ADDENDUM NO. 03
JAESC Fencing Project
RFQ #0879-8079-800-7

October 28, 2024

REQUEST FOR INFORMATION

Subject: FW: Request for Information - J.A.E.S.C. Fencing and gate Project number 0879-8079-800-7

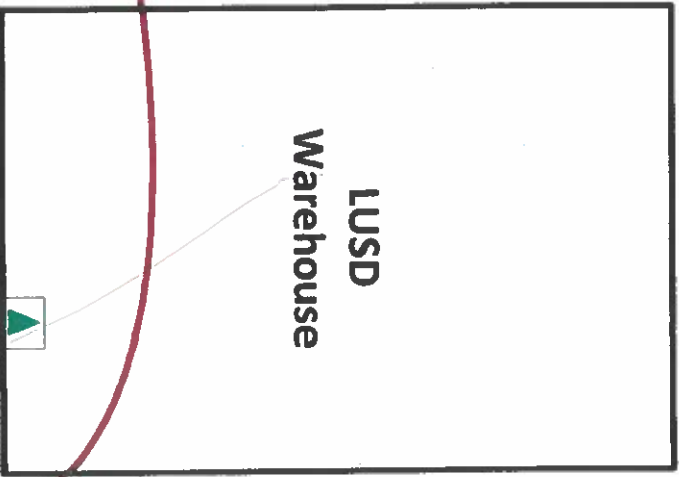
See Diagram "A" West Side
Expanded for Conduit Details

We will do
everything on
this door

We will do
everything on
this door

See Diagram "B" East Side
Expanded for Conduit Details

Diagram "A" - West Side Expanded

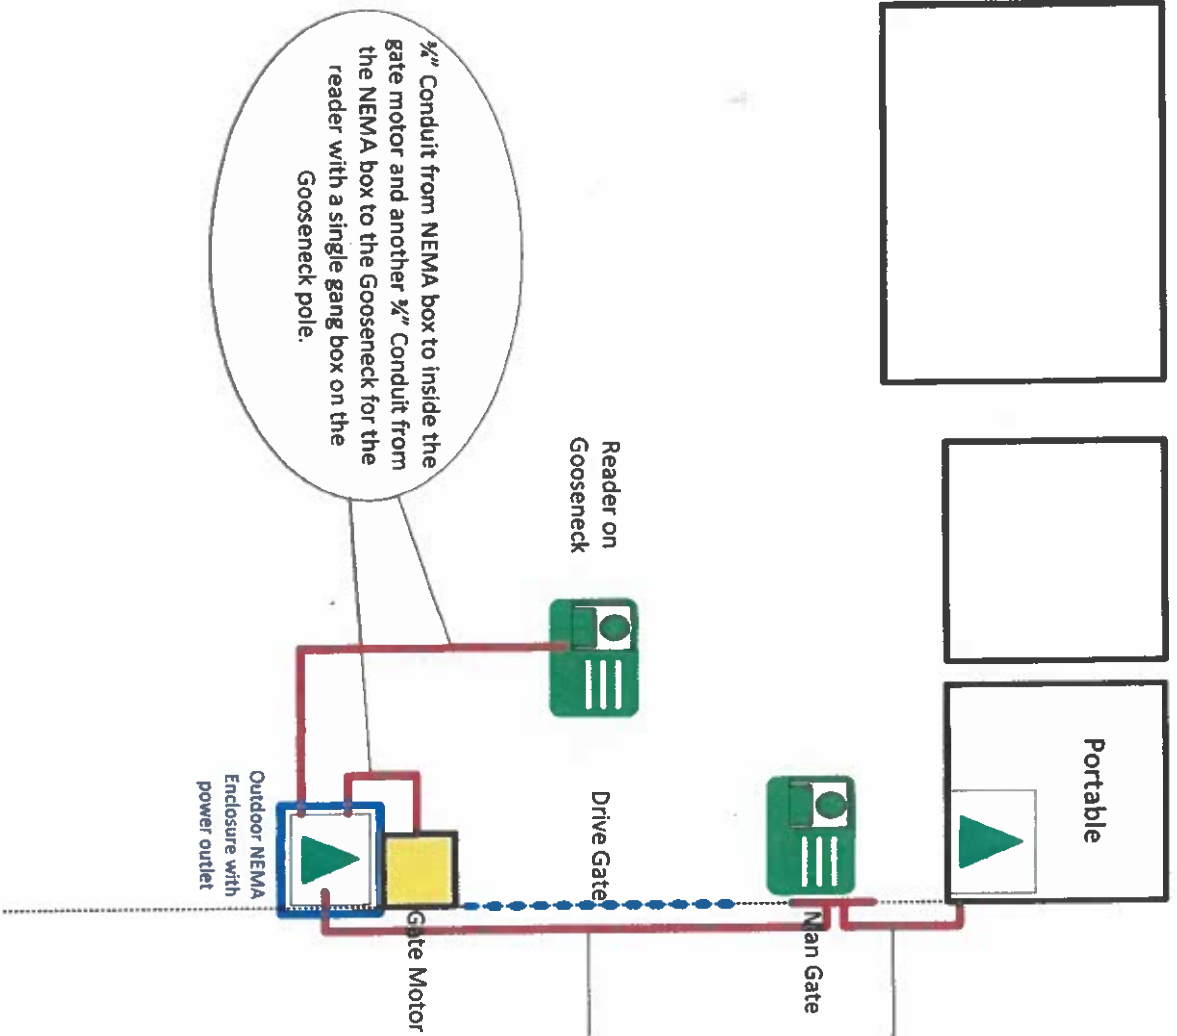
3/4" Conduit from NEMA box to inside the gate motor and another 3/4" Conduit from the NEMA box to the Gooseneck for the reader with a single gang box on the Gooseneck pole.

Double gang outdoor box on portable penetrating above drop tile with 1" conduit ran to a double gang box on the pole of strike side on man gate.

1" Conduit from that double gang box on man gate to a 16" x 16" x 8" NEMA enclosure with a lock and 120V power outlet inside - off to the far side in top or bottom corner.

M&O Contractor to install and supply all conduits, boxes, fittings, NEMA enclosures, and the Gooseneck for us to complete the access control project. (We will connect to sub-owned gate motor.)
